Change Order, Construction Manager as Adviser Edition

PROJECT: <i>(name and address)</i> Christian County High School 5185 Fort Campbell Blvd Hopkinsville, KY 42240	CONTRACT INFORMATION: Contract For: BP 030-01 (PO) - General Trades Date: September 08, 2023	CHANGE ORDER INFORMATION: Change Order Number: 006 Date: February 9, 2024
OWNER: <i>(name and address)</i> Christian County Board of Education 200 Glass Avenue Hopkinsville, KY 42240	ARCHITECT: <i>(name and address)</i> Hafer PSC 21 Southeast Third St, Ste 800 Evansville, IN 47708	CONSTRUCTION MANAGER: <i>(name and address)</i> Alliance Corporation 116 E. College Street Glasgow, KY 42141
CONTRACTOR: <i>(name and address)</i> Architectural Sales 600 N. 6th Avenue Evansville, IN 47706

PROPOSAL REQUEST

Project:	Christian County High School 5185 Ft. Campbell Blvd Hopkinsville, KY 42240	PR No.:	001
		Date:	October 13, 2023
Owner:	Christian County Public Schools 222 Glass Ave Hopkinsville, KY 42240	Project Number:	2106-204
		Contract for:	
To:	Tim Geegan Alliance Corporation 116 E. College Steet Glasgow, KY 42141		
RE:	State Required Egress Door Modifications, Misc Door Changes and Minor structural clarifications.

PR-1A1

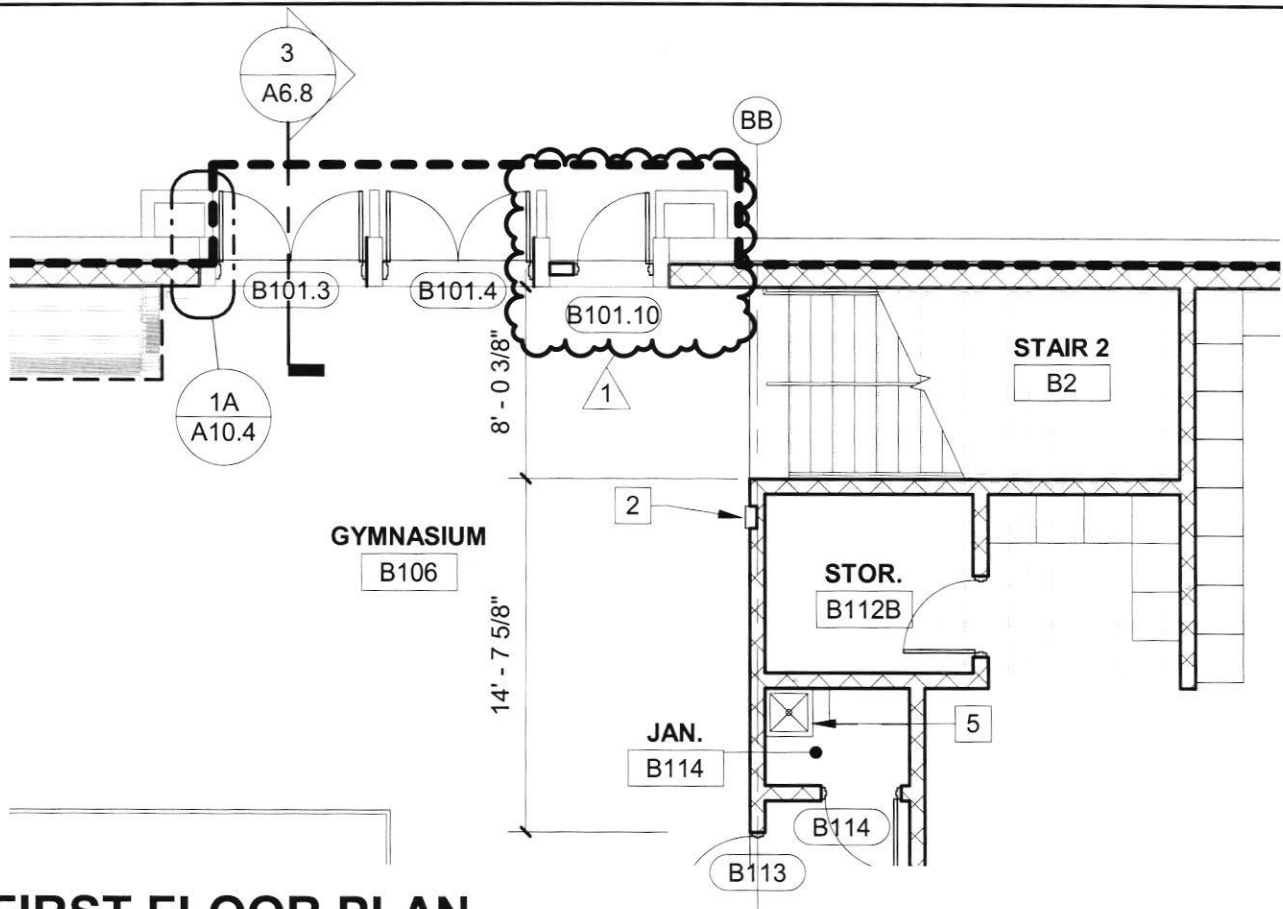
- 1) At Gymnasium B106, add opening B101.09 as shown on attached plans and details and add electrical items as indicated.
- 2) At Gymnasium B106, add opening B101.10 as shown on attached plans and details. Modify concrete portal to accommodate door and add electrical items as indicated.

<table><tr> <td style="width: 50%;">ARCHITECTS PROJECT NO.</td><td style="width: 50%;">DATE:</td></tr><tr> <td colspan="2" style="text-align: center; font-size: 2em;">PR-1A2</td></tr></table>

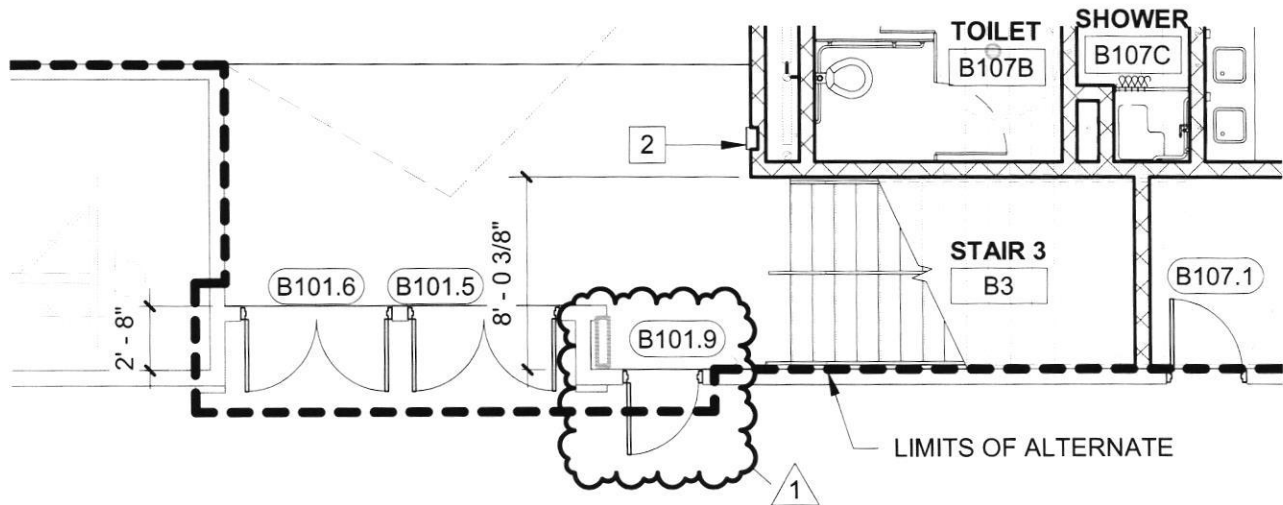
- 3) At Entry C100C, delete overhead coiling fire-rated tornado door C100C. Add openings C100C.2 and C100C.3 s shown on attached plans and details. Modify concrete portal to accommodate doors. Construct brick wing walls as shown for magnetic hold opens.

PR-1A3

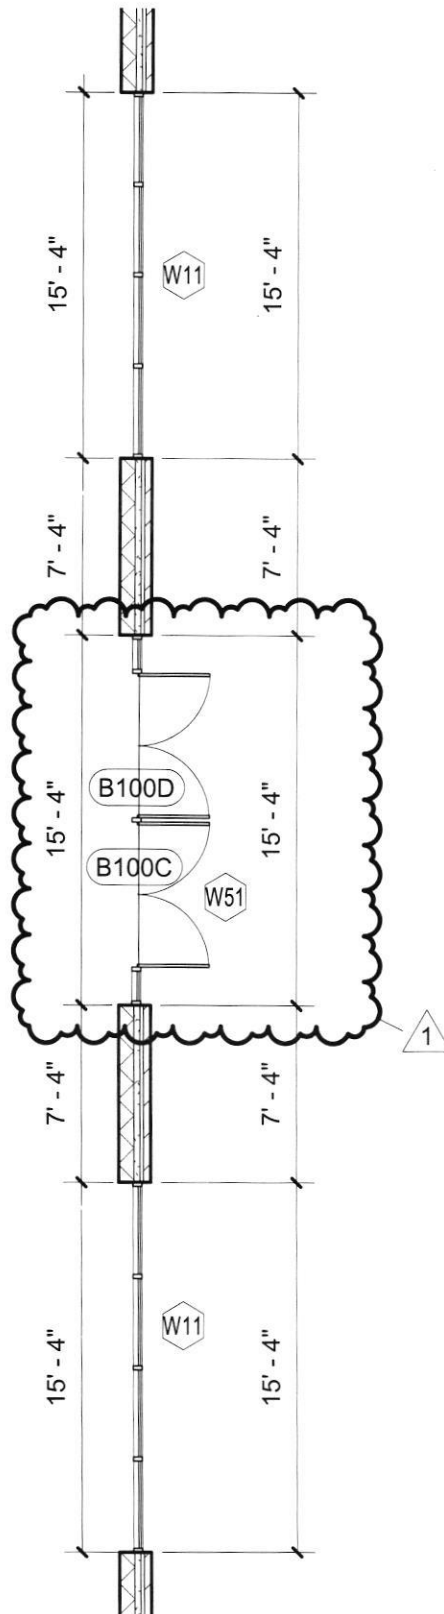
- 4) At Corridor B100C, add opening B100D to frame W51 as shown on attached plans and details.
- 5) Change width of door D106 from 3'-0" to 3'-8".
- 6) Provide removable mullions in lieu of rods at exit devices at all pairs of doors in hardware sets #1, #2, #3, #4, #17, #36 & #37.

PR-1S6

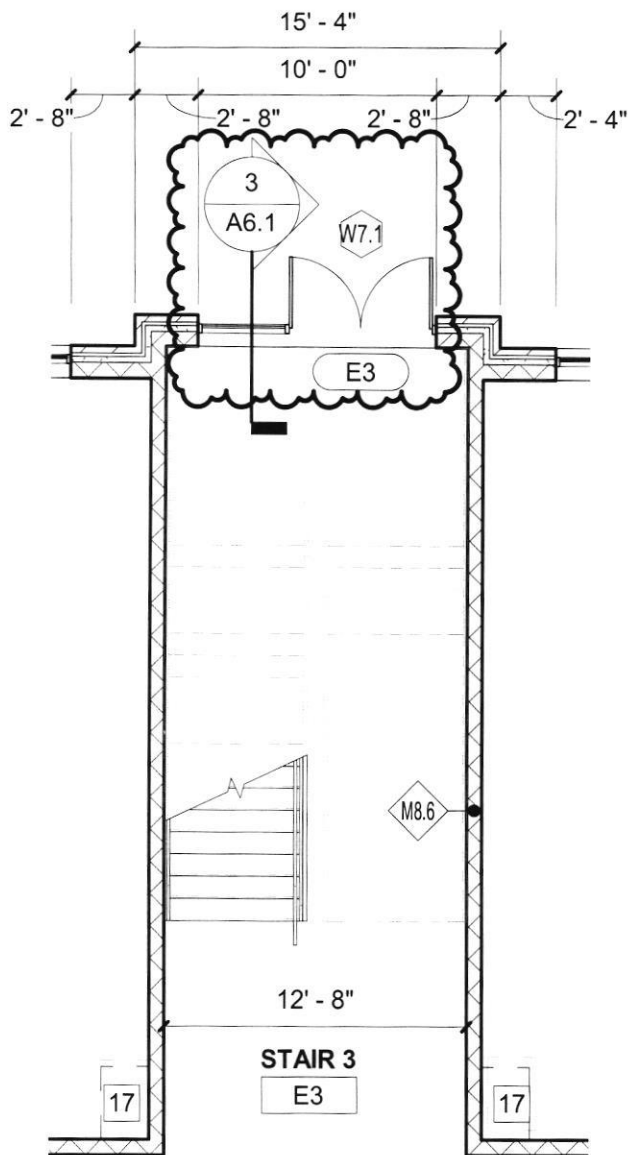
- 9) See Details 2/PR-1S1, 1/PR-1S3, 1/PR-1S6, 1/PR-1S7, 1/PR-1S9, 1/PR-1S10 for clarification on footing requirements.

PR-1A6

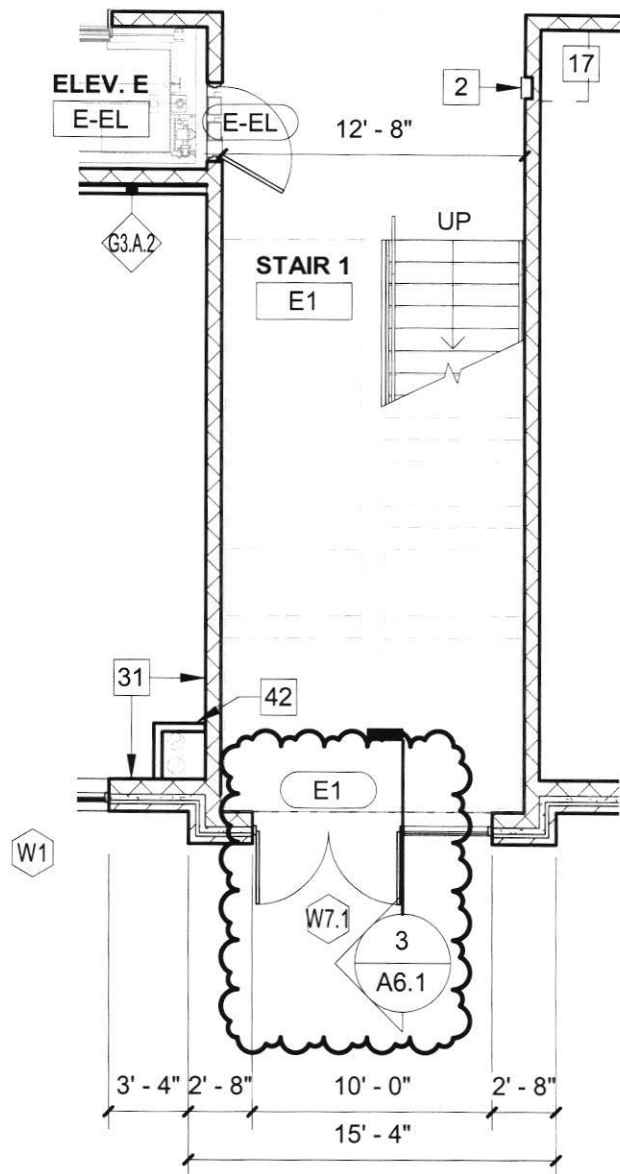
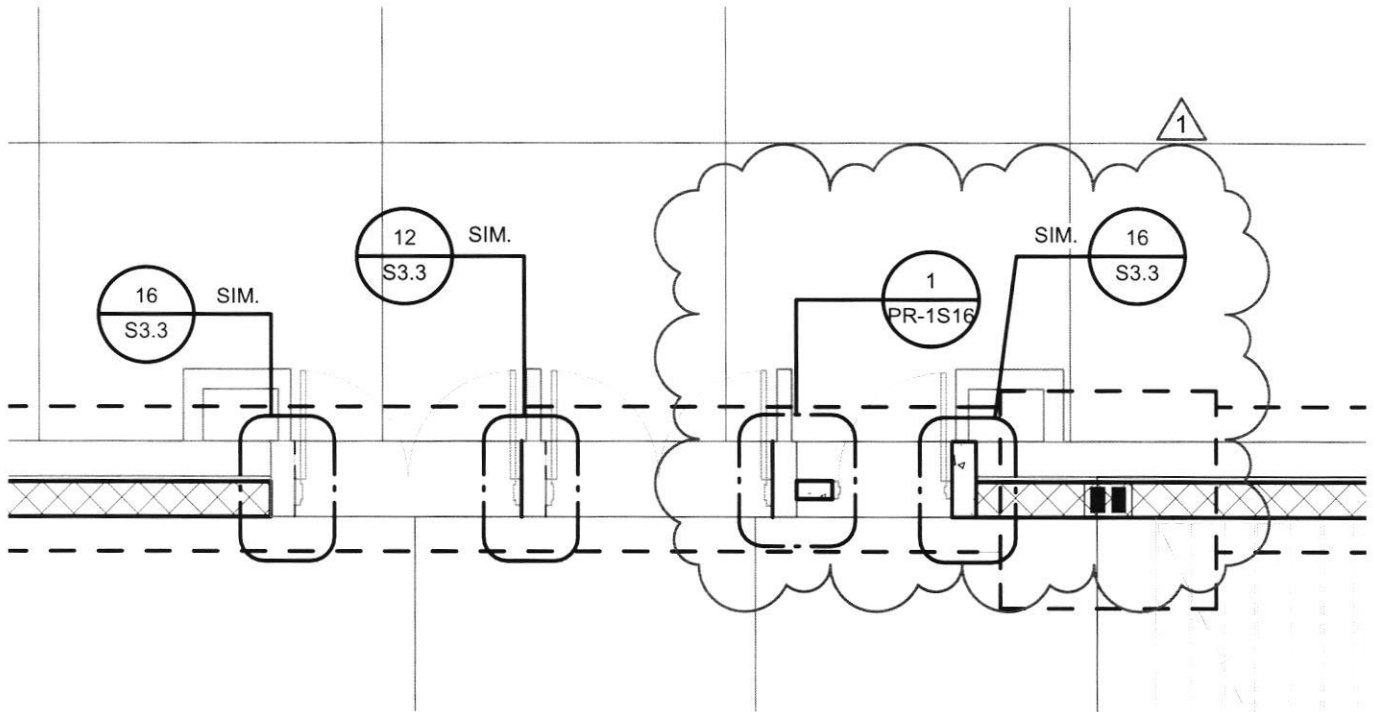
- 7) Provide removable mullions in lieu of rods at exit devices at doors A100J.2, C101.5 & C101.6 in hardware set #26.
- 8) At E1 & E3, modify openings E1 & E2 to be a pair of exterior doors as shown on attached plans and elevations and details. Modify frame W7 at these openings only to be W7.1.

PR-1S5

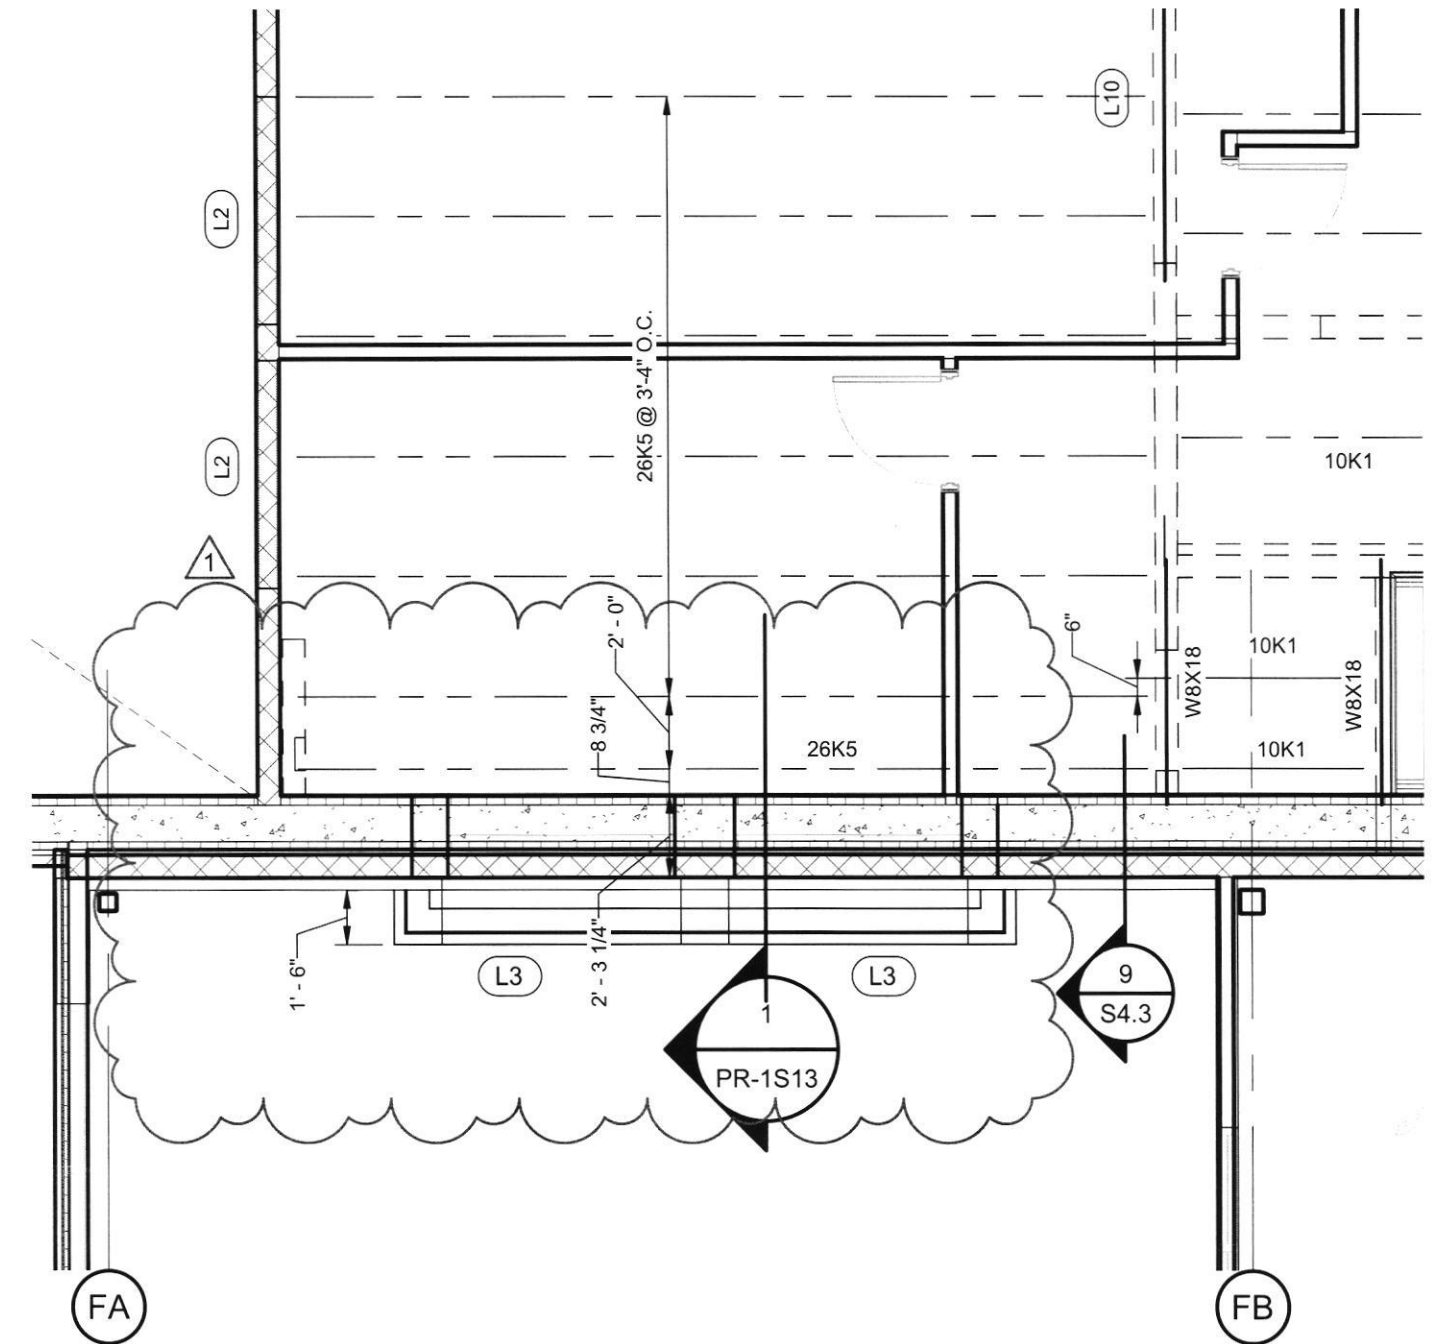
- 10) See 1/PR-1S5 for clarification on CMU wall height adjacent to CLs FF/F5
- 11) See 1/PR-1S8 for Area G lintel clarification.
